Summary of Items Discussed in 1/2023 APSEC Discussion Forum on 10 February 2023

16. GFA Calculation of Covered Area under Roof Feature

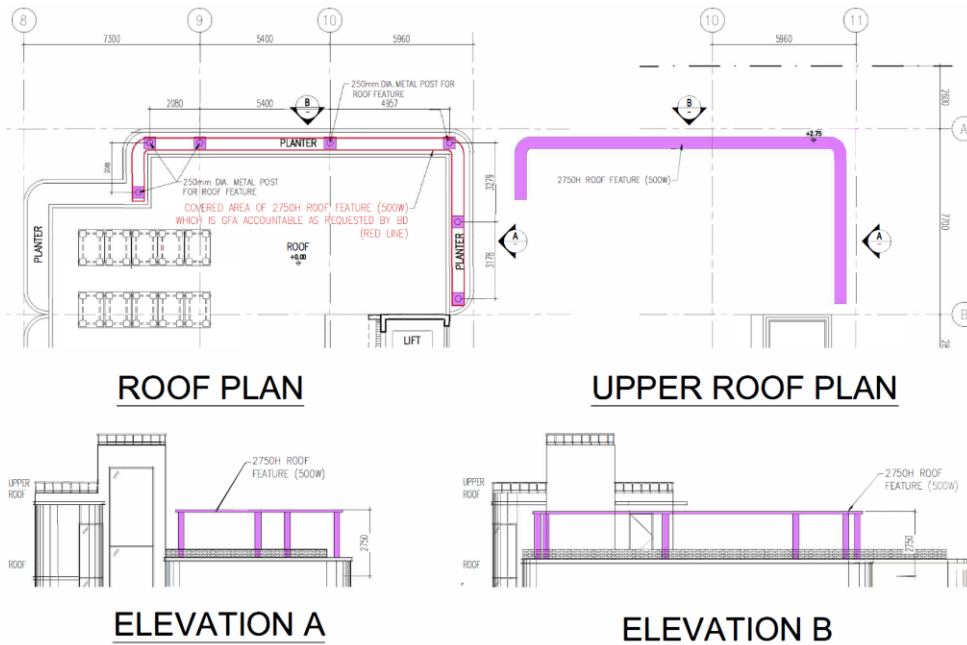
We recently received comment from BD that the covered area under a 500 mm wide roof feature on the roof of a single family house as illustrated in the attached drawing shall be GFA accountable. The roof feature is 2750 mm high from roof level and open in design, which is not likely to be abused. We opined that the roof feature shall adopt similar approach as other architectural features projecting from the external wall, such that its covered area shall not be GFA accountable given that the roof feature has a maximum width of 500 mm and is open in design. Please confirm if our understanding is correct.

BD advised that GFA calculation for roof features on roof of a single family house would be considered on case basis, taking into account the chance of abuse of the roof features. For the drawing illustrated by PBSCA, BD advised that in consideration of the size of the roof feature and the low chance of abuse, the area covered by the 500 mm wide roof feature might be exempted from GFA calculation.

A PERFORATED BRICK WORK FEATURE WALL
- ELEVATION (MAX. 500MM THICK)

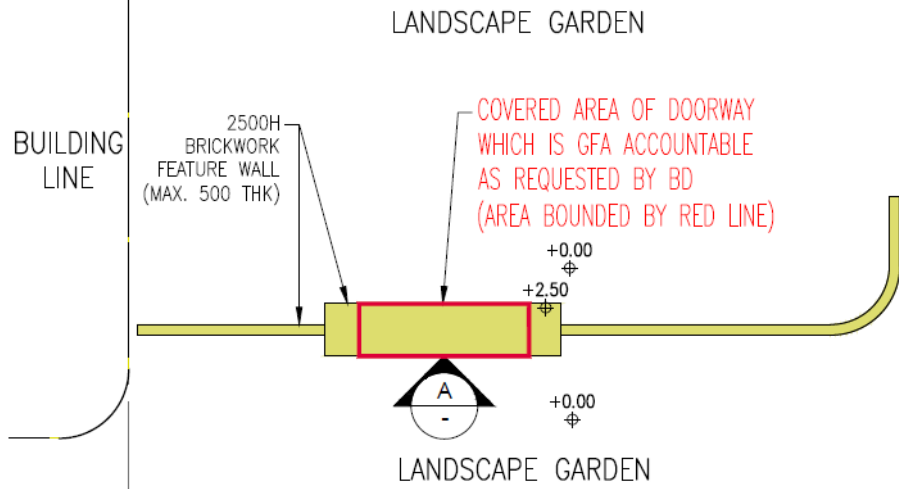
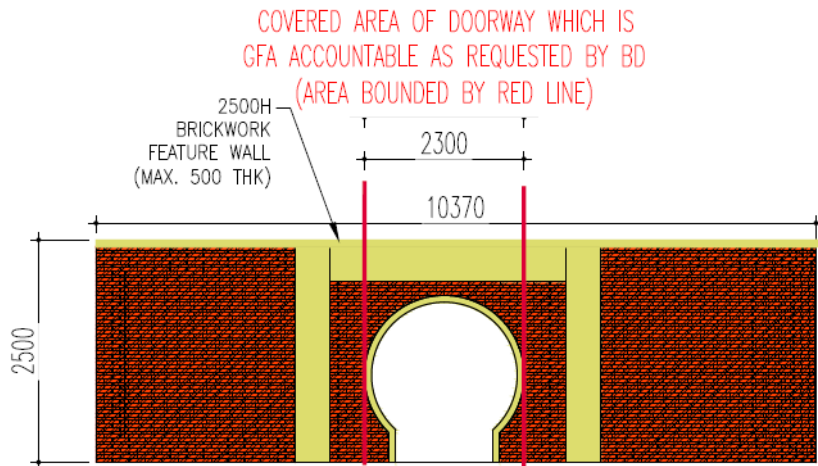
17.	<p><u>GFA Calculation of Covered Area under Doorway of Landscape Feature Wall</u></p> <p>We recently received comment from BD that the covered area under the doorway of a standalone feature wall as illustrated in the attached drawing shall be GFA accountable. The feature wall is a landscape feature of 2500 mm high with a maximum thickness of 500 mm and the doorway is only 2300 mm wide. Given that the doorway is only an opening at the landscape feature wall and the covered area for such doorway is minimal, we opined that the covered area of the doorway of landscape feature wall shall <u>not</u> be GFA accountable. Please confirm if our understanding is correct.</p>	<p>BD advised that landscape features of reasonable size and rare chance of abuse might be exempted from GFA calculation. For the drawing illustrated by PBSCA, BD advised that the covered area under the doorway of a genuine landscape feature might be exempted from GFA calculation.</p>

A MAIN ENTRANCE ENTRANCE PORTAL
- ELEVATION

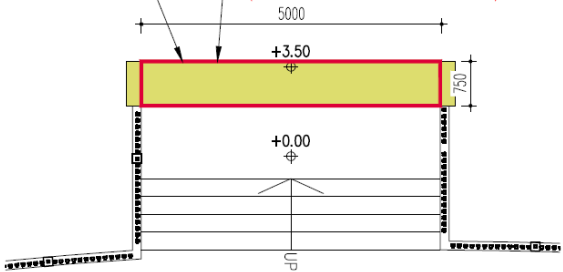
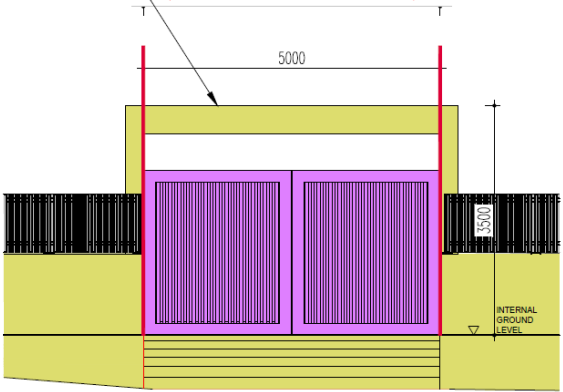
<p>18.</p>	<p><u>GFA Calculation of Covered Area under Portal of Metal Gate at Main Entrance</u></p> <p>We recently received comment from BD that the covered area under the portal for metal gate at main entrance as illustrated in the attached drawing shall be GFA accountable. The portal is 3500 mm high and 5000 mm wide with a maximum thickness of 750 mm. It is common to have a portal for the access gates at main entrance of a development for better architectural design which at the same time provides better structural stability for the heavy metal gates. As there are no other structures nearby, the chance of abuse for the portal is minimal. We opined that the covered area under the portal for metal gates at main entrance shall <u>not</u> be GFA accountable, given that the size of the portal is not excessive and there are no other structures nearby. Please confirm if our understanding is correct.</p>	<p>BD advised that the covered area under the portal for metal gate at main entrance of a development might be exempted from GFA calculation on case merits if the size of the portal was commensurate with the scale of the development.</p>

COVERED AREA WHICH IS GFA
ACCOUNTABLE
AS REQUESTED BY BD
(AREA BOUNDED BY RED LINE)
